**RARITAN BAY AND SANDY HOOK BAY
HIGHLANDS, NEW JERSEY
COASTAL STORM RISK MANAGEMENT
FEASIBILITY STUDY**

**APPENDIX D
COST ENGINEERING
May 2020**

Attachment C3
ATR Comments

REVIEW by: W Bolte 16 December 2019

Figure C1 – Construction Schedule

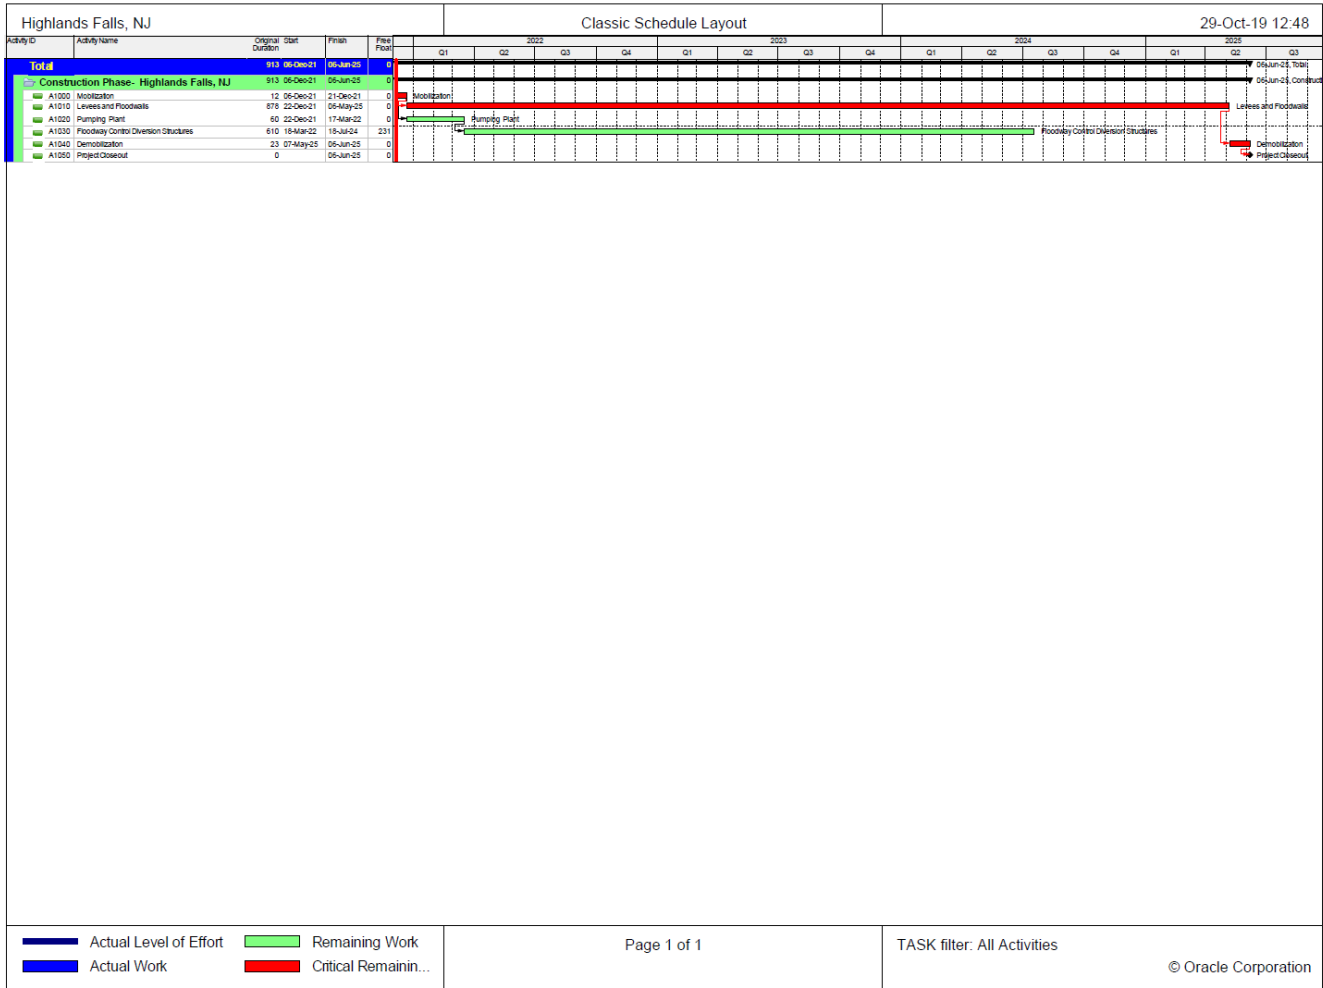
Midpoint: Per construction schedule provided, the construction will start on 06-Dec-21 and will be completed on 06-Jun-25. Please update the midpoint of construction and the midpoint of design in the TPCS.

Response: Concur. Midpoint of construction and design has been updated within the TPCS spreadsheet.
